# CITY OF ALBUQUERQUE

RE: **ABQ Biopark Elephant Exhibit**  
**903 10<sup>th</sup> St SW**  
**Engineer's Stamp Date 6/2/17**  
**Hydrology File: K13D034B**

GRADING &  
DRAINAGE  
PLAN

CG-101

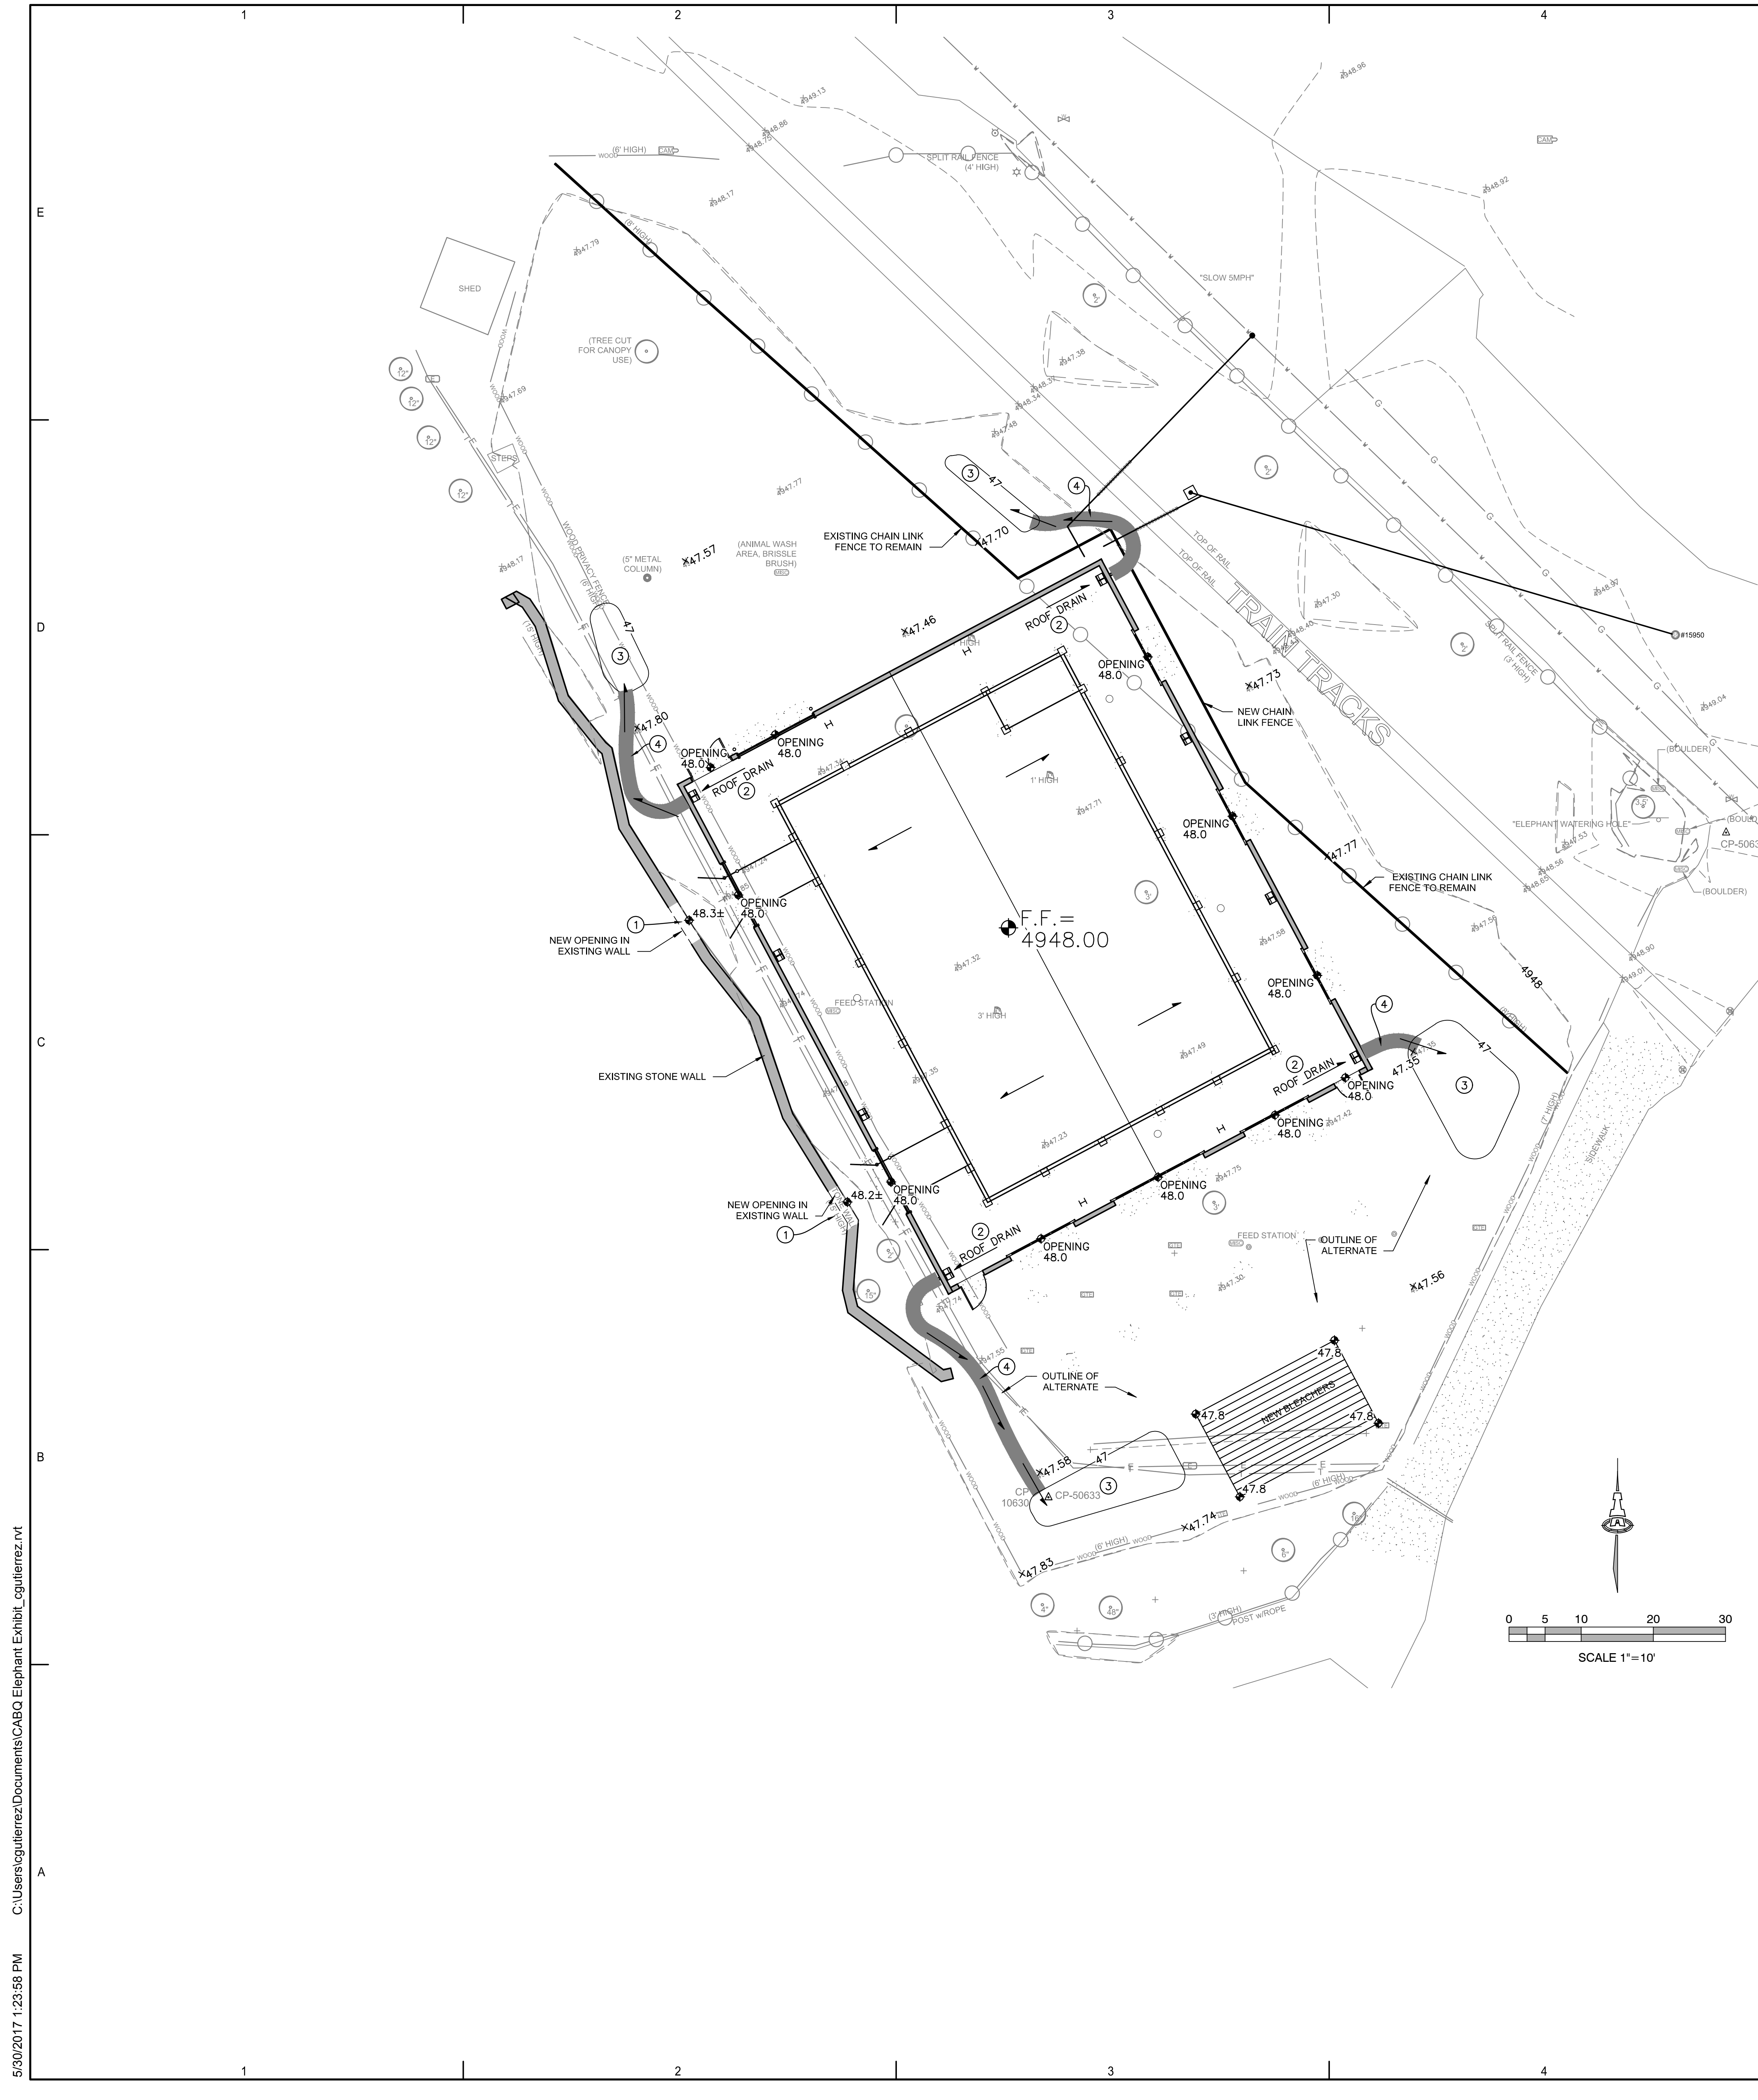
Based on the information provided in the submittal received on 6/5/17 the above-referenced Grading and Drainage Plan cannot be approved for building permit until the following are addressed:

1. Developed flows must account for all offsite flows entering the enclosure and volume must be provided for the 100-yr, 10-day volume.
2. Provide the maximum water surface elevation for the 100-yr, 10-day volume.
3. The finished floor of the new elephant barn must be elevated at least 1' above the MWSE.
4. Expand the viewport to show surrounding contours and outbuildings potentially affected by the MWSE.
